ADDENDUM NO. 6

October 15, 2024

CORNER CANYON HS FIELD HOUSE

Addendum #6

SHEET NUMBER
CU301

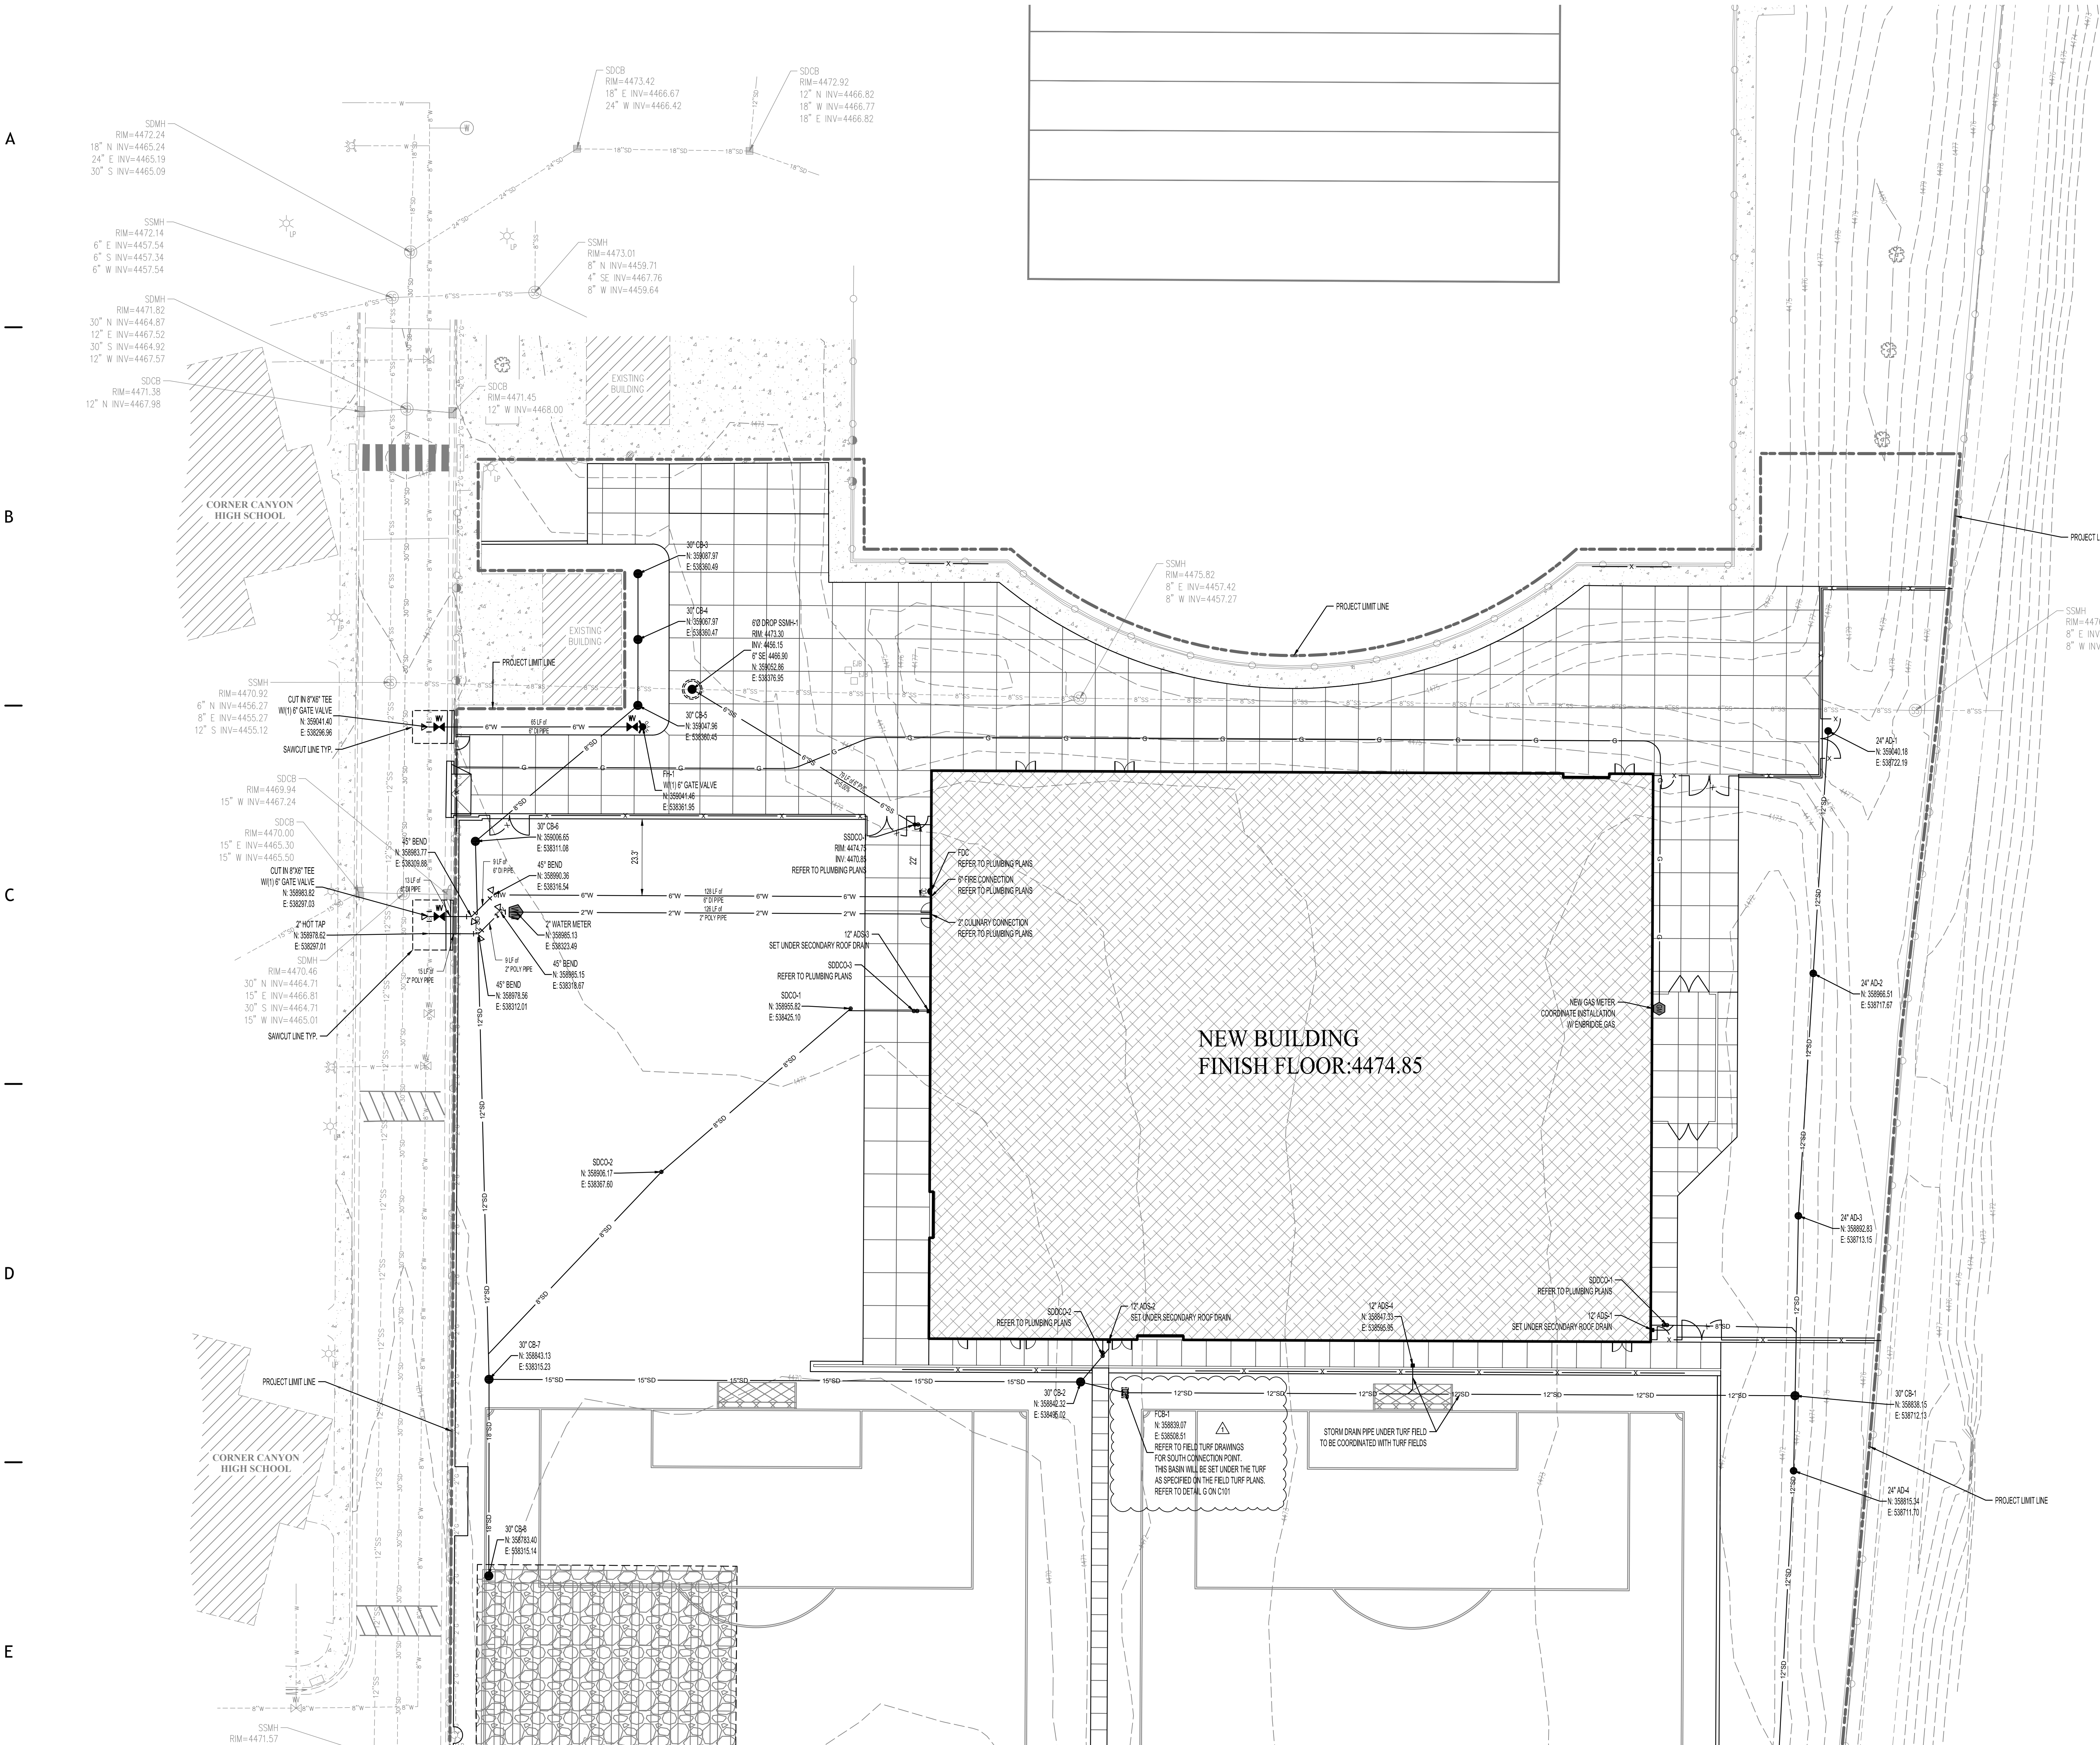
CU301

- Revised FCB-1 note.

SHEET NUMBER
CG401

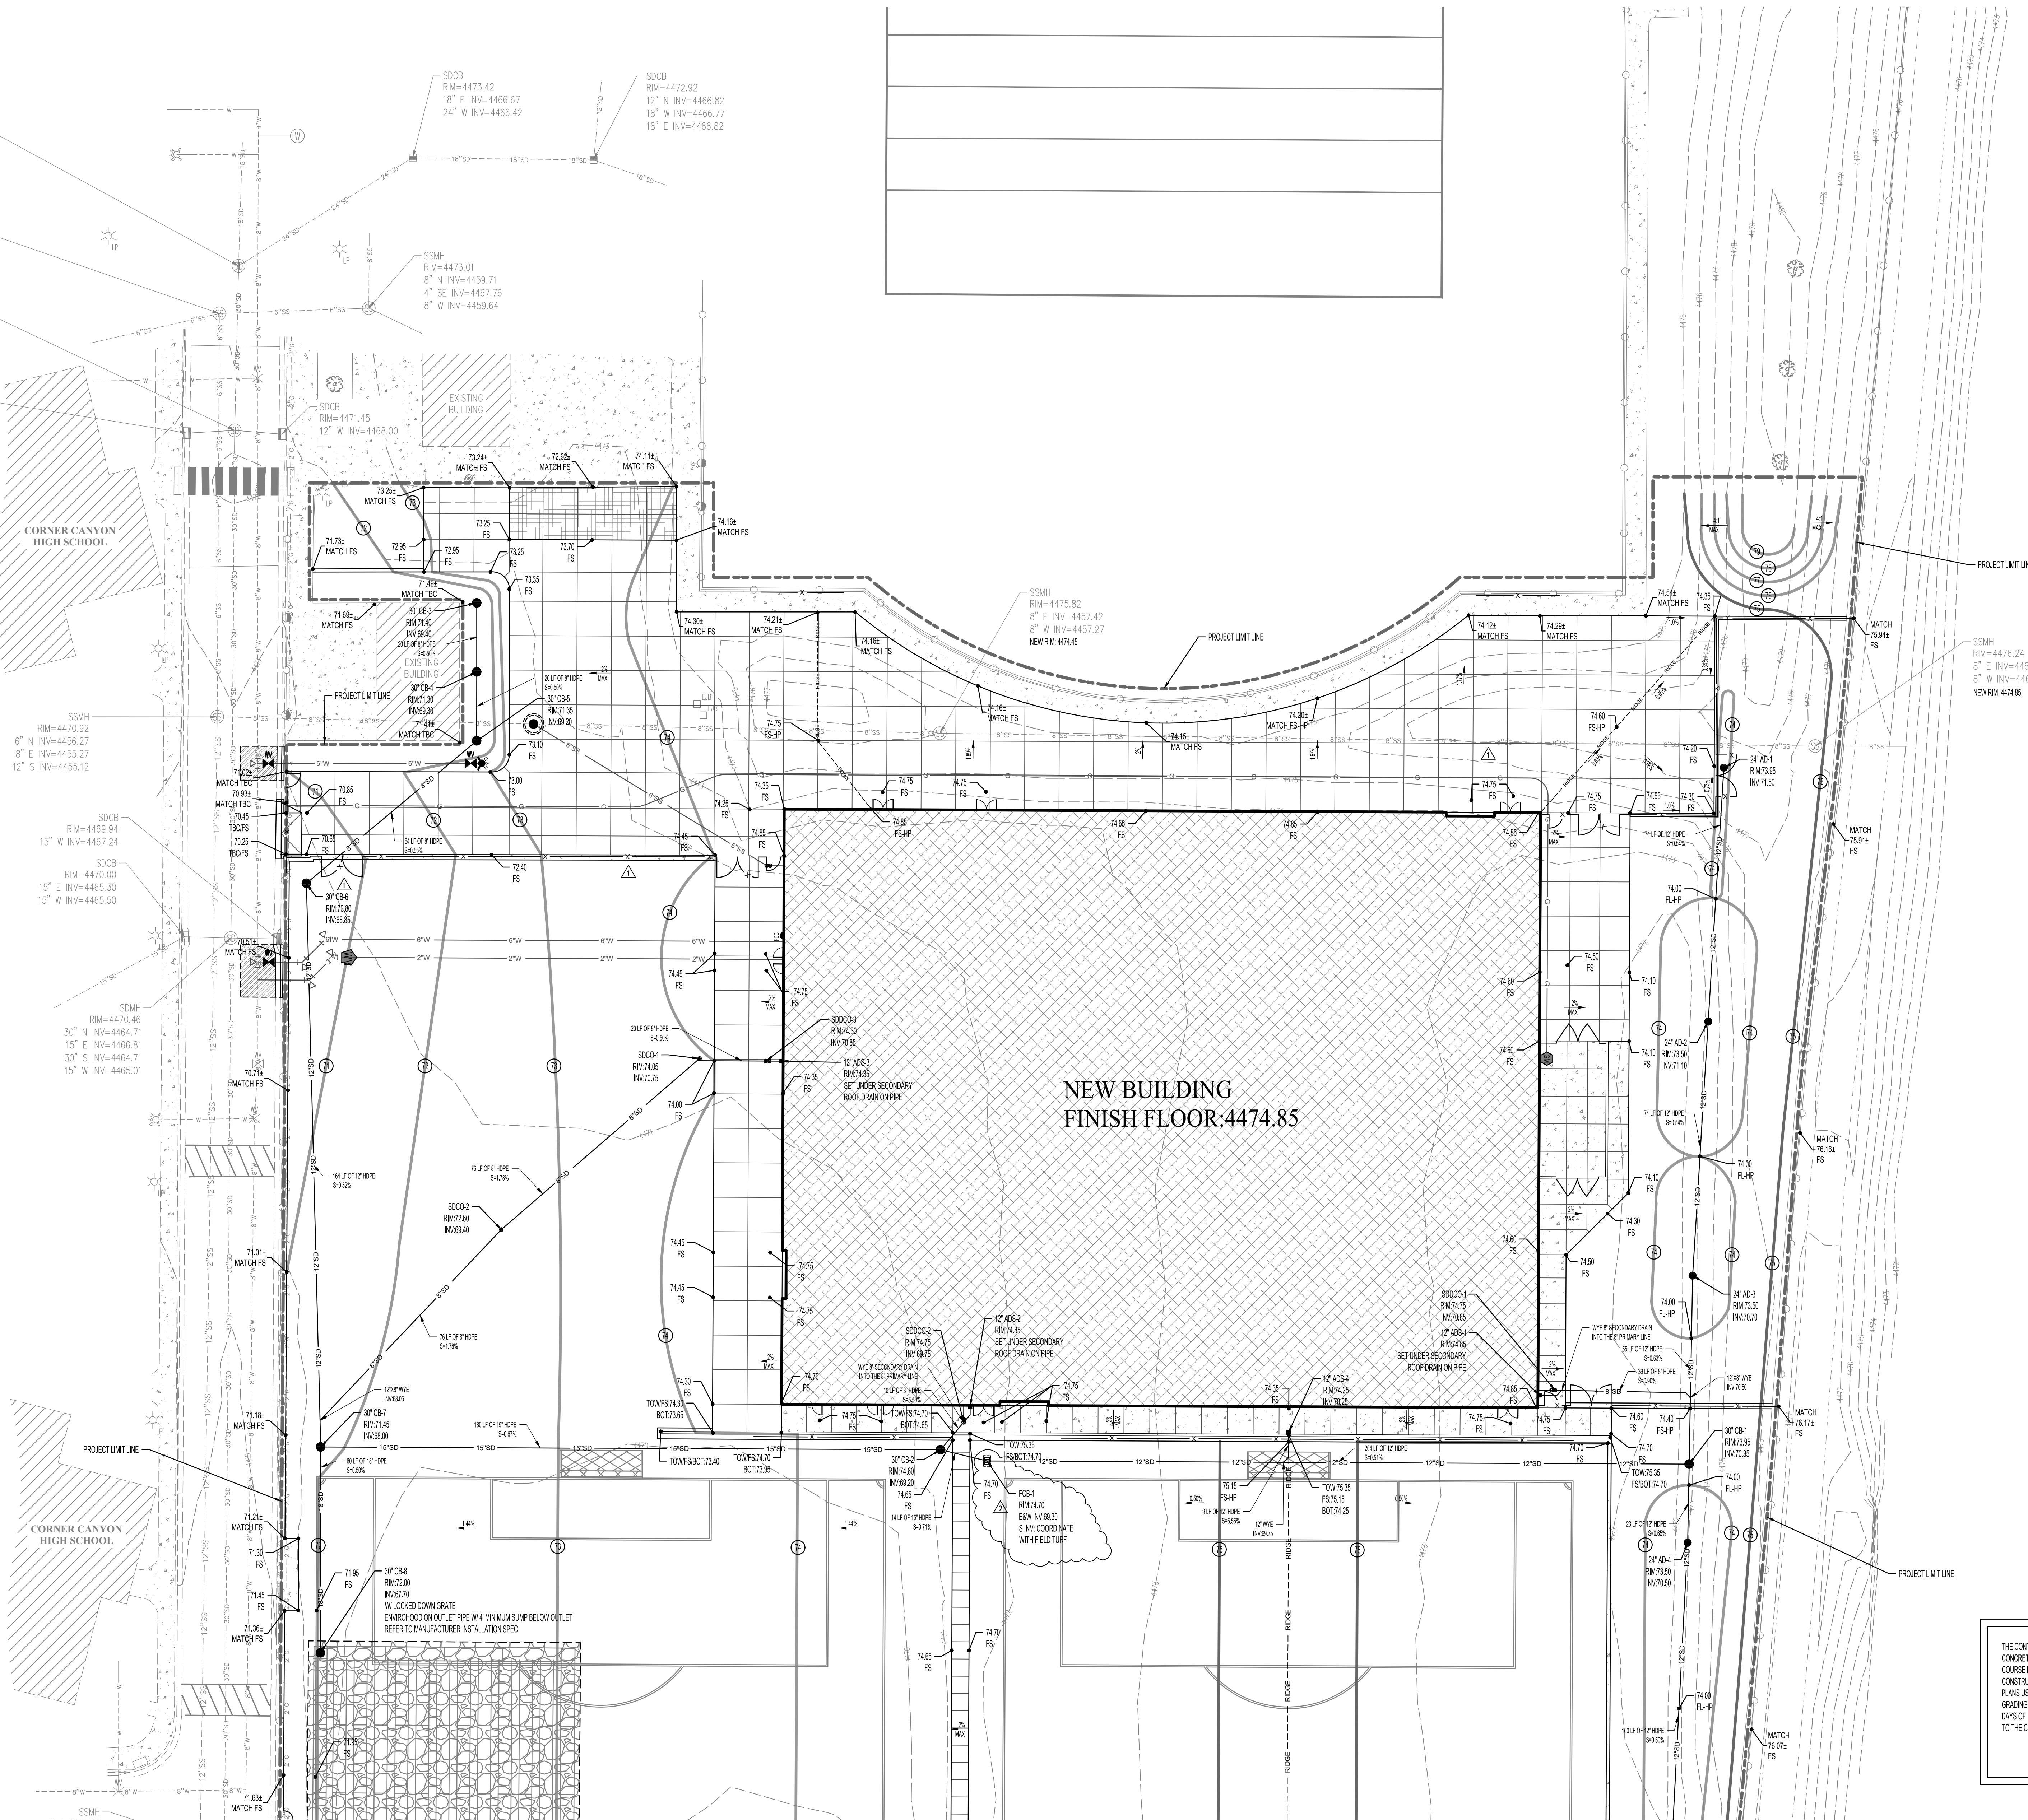
CG401

- Revised FCB-1 note.
